APPEAL SUMMARY

Appeal ID: 24649	Project Address: 915 NE Schuyler St
Hearing Date: 2/24/21	Appellant Name: Hali Knight
Case No.: B-012	Appellant Phone: 9713523935
Appeal Type: Building	Plans Examiner/Inspector: Steven Mortensen
Project Type: commercial	Stories: 9 Occupancy: R-2 Construction Type: 1-A
Building/Business Name:	Fire Sprinklers: Yes - Throughout
Appeal Involves: Alteration of an existing structure	LUR or Permit Application No.: 20-185703-CO
Plan Submitted Option: pdf [File 1] [File 2] [File 3] [File 4] [File 5]	Proposed use: Residential

APPEAL INFORMATION SHEET

Figure 1: Proposed location of new HSS 6" X 6" X 3/8" beams

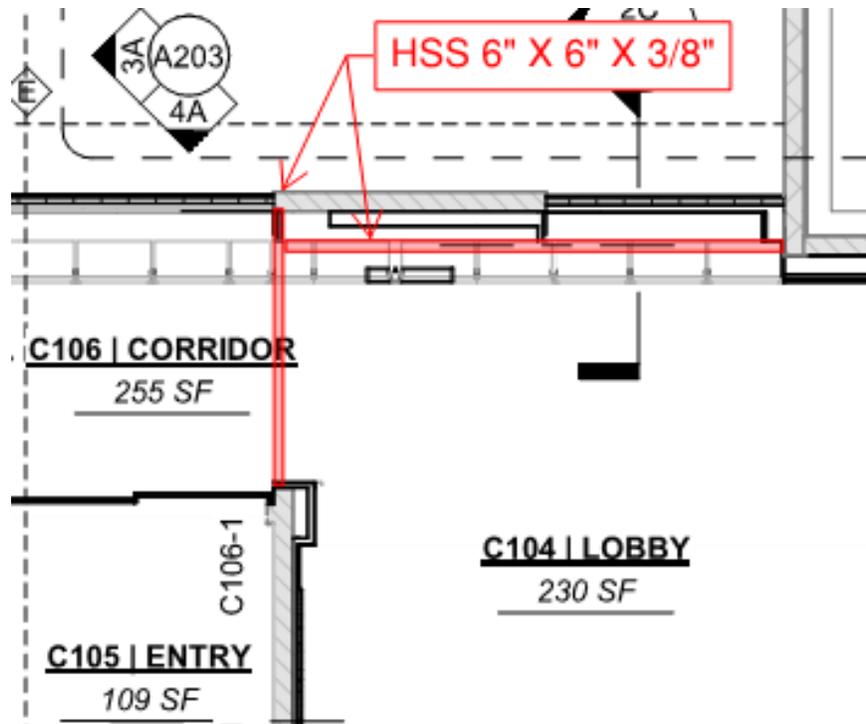
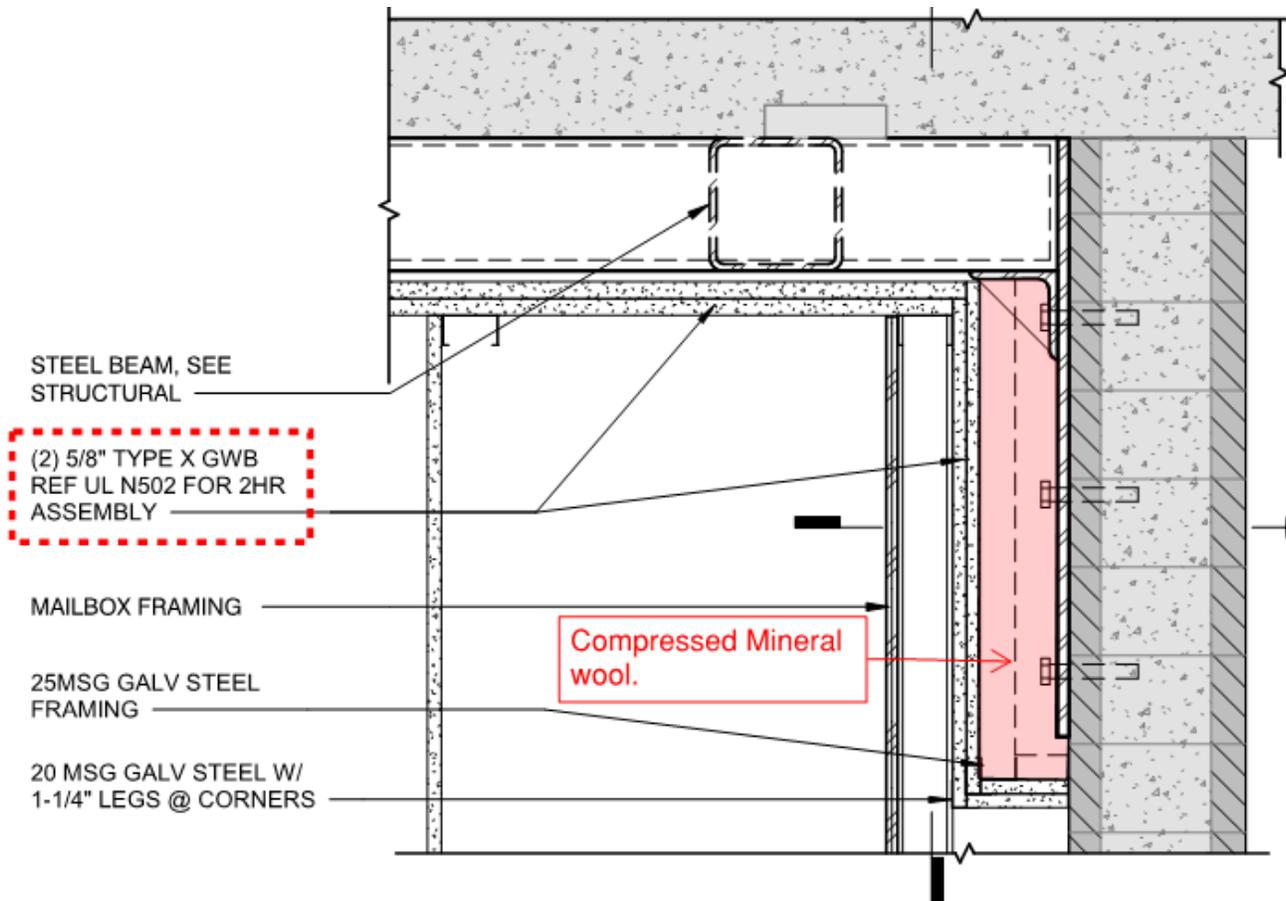
Code Modification or Alternate Requested This appeal demonstrates 2-hour protection of new structural HSS beams installed in the lobby based on the attached engineering analysis.

The primary function of the HHS members is to support the existing roof of the lobby. Membrane protection will be provided. However, complete encapsulation will not be required as the members only support the roof and no floors per OSSC 704.3. The proposed member assembly consists of 6x6 x 3/8" HSS sections. The beam will be bolted with a flat steel plate to the exterior CMU wall with the connection and beam both being protected with a minimum of two layers of 5/8" Type X gypsum board installed on the exposed faces as shown in the attached engineering analysis. Compressed mineral wool will fill the cavity between the gypsum wallboard (GWB) and steel plate.

- 3. Alternate 2 hour fire rated HSS beam assembly with engineering analysis: Denied. Proposal does not provide equivalent Life Safety protection.**
- 4. Alternate 2 hour fire rated penetration of floor / ceiling assembly by breakroom range exhaust duct with engineering analysis: Granted as proposed for specific location addressed in E.J. letter.**

Figure 1: Proposed location of make-up air ducting.

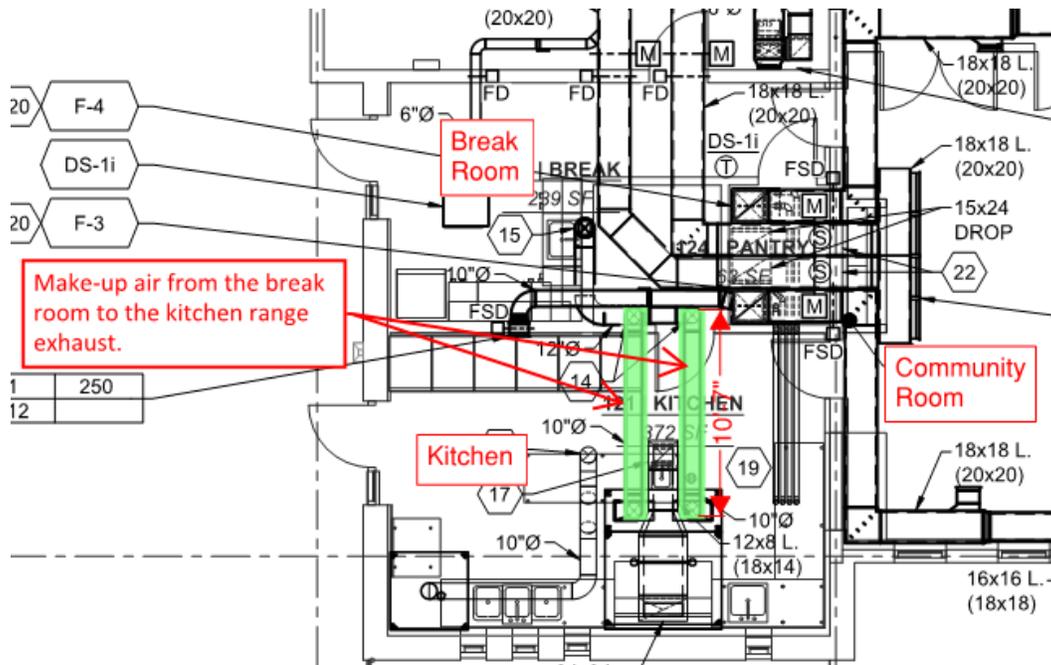
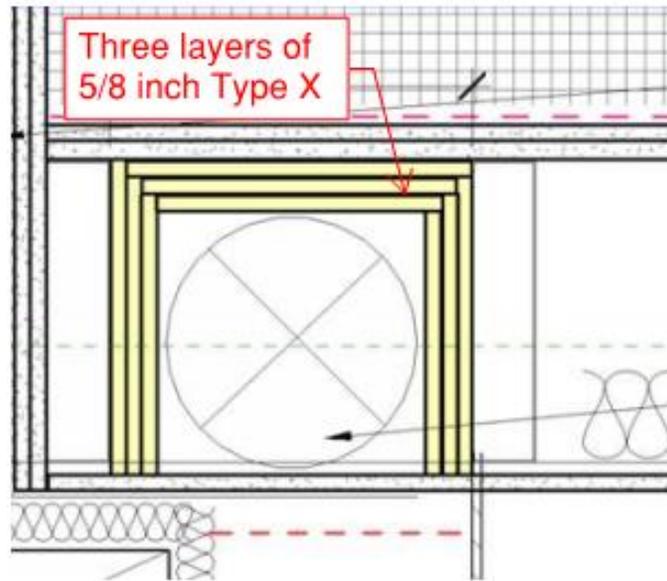
Code Modification or Alternate Requested This appeal demonstrates fire protection equivalent to or exceeding code requirements for makeup air inlet ducts that penetrate a 2-hour roof/ceiling assembly based on the attached engineering analysis.

The make-up air for the kitchen range will come from the break room via two 10-foot sections of ducting. The ducts will penetrate the roof assembly which has a 2-hour rating per OSSC T601. To maintain the required 2 hour rating it is proposed to encase the duct with three layers of 5/8 inch Type X Gypsum wallboard.

Fig 1: C-Channel Locations.

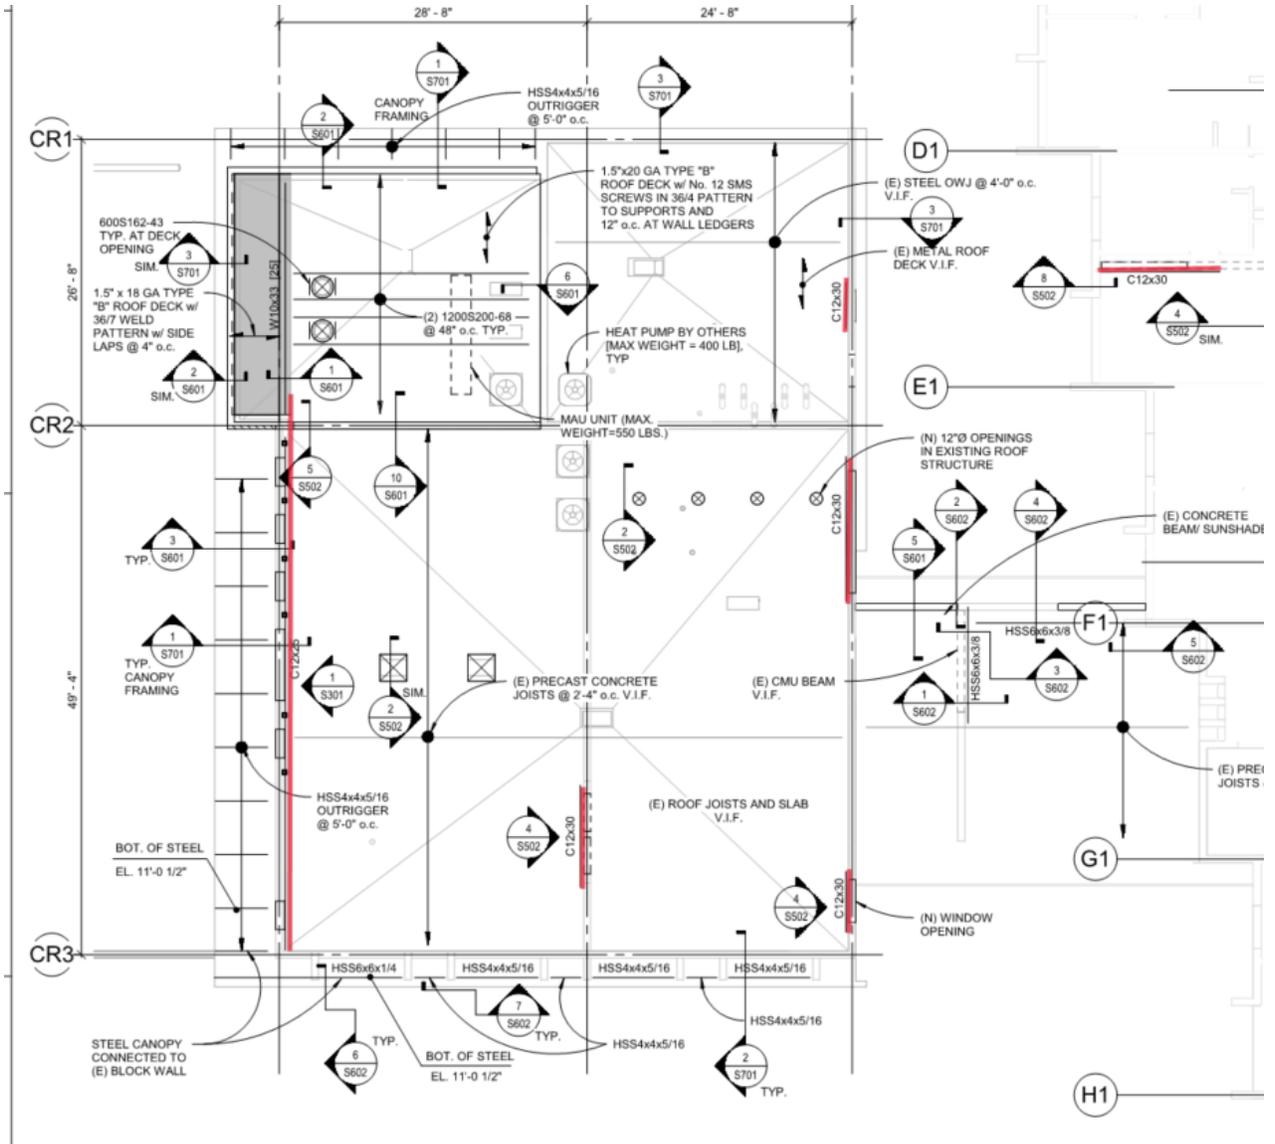
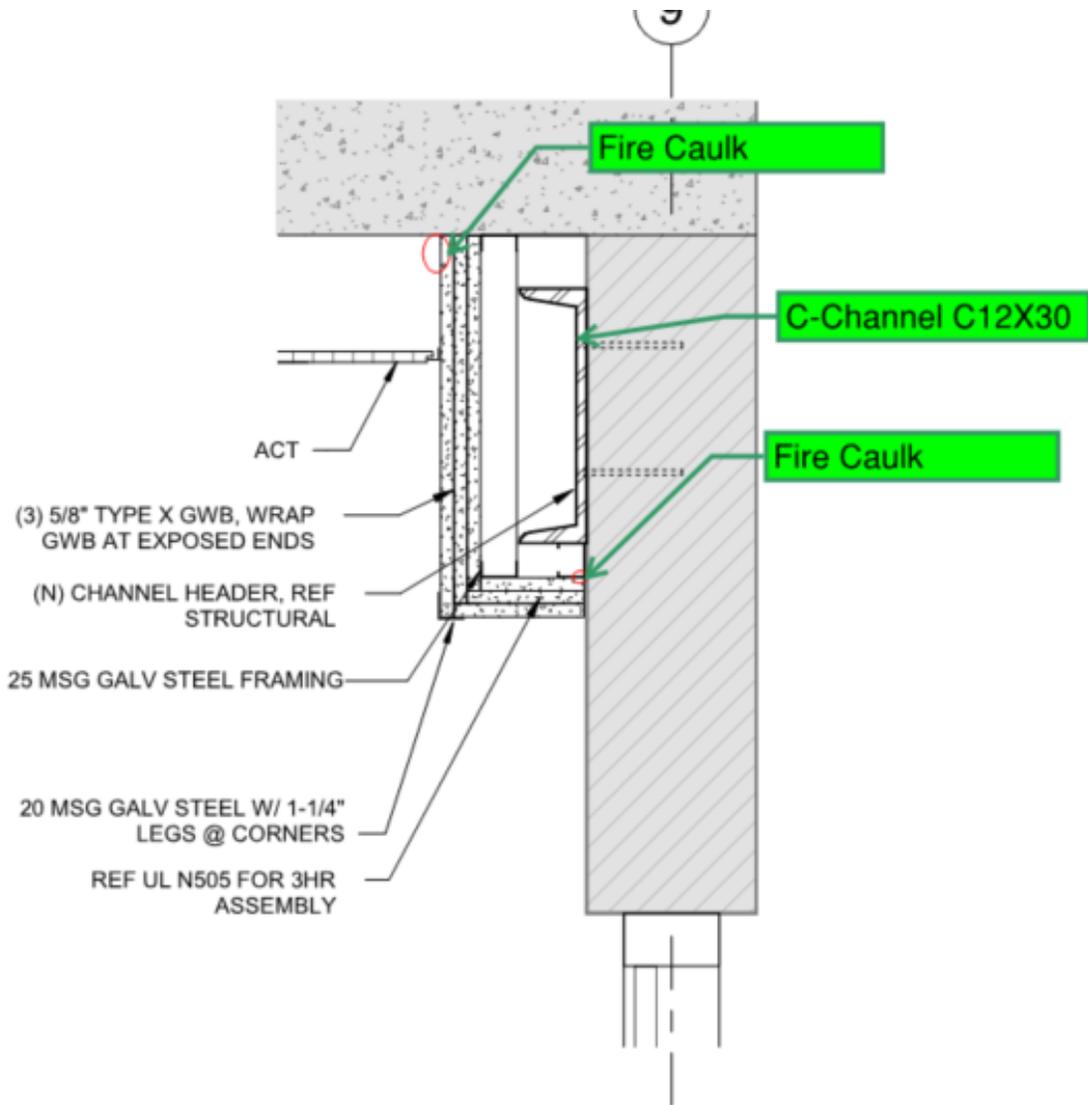
Code Modification or Alternate Requested This appeal demonstrates 3-hour protection of structural channels at the existing walls based on the attached engineering analysis.

The proposed C-Channel of C12x30 members located against the existing walls (see attached engineering judgment letter) Per 2019 OSSC table 601, primary structural members are required to be minimum 3 hr. fire rated for the construction type. It is assumed that the beam will be exposed to fire on the left side and the assembly will require continuous protection from three sides.

During this evaluation, UL test N505 was considered, where the minimum required W/D ratio (0.704) is less than the proposed W/D ratio (1.26). The tested beam utilizes 3 layers of 5/8" minimum of Type X gypsum board protecting the beam to provide 3-hour fire-resistance (Figure 2). The proposed C-Channel has greater inherent fire-resistance and is additionally protected in the same thickness of Type X gypsum wallboard to provide greater or equivalent protection to the 3-hour fire rated UL N505 beam.

- 5. Alternate 3 hour fire rated structural channel assembly with engineering analysis: Hold for additional information. See note below regarding the process for submitting additional information.**
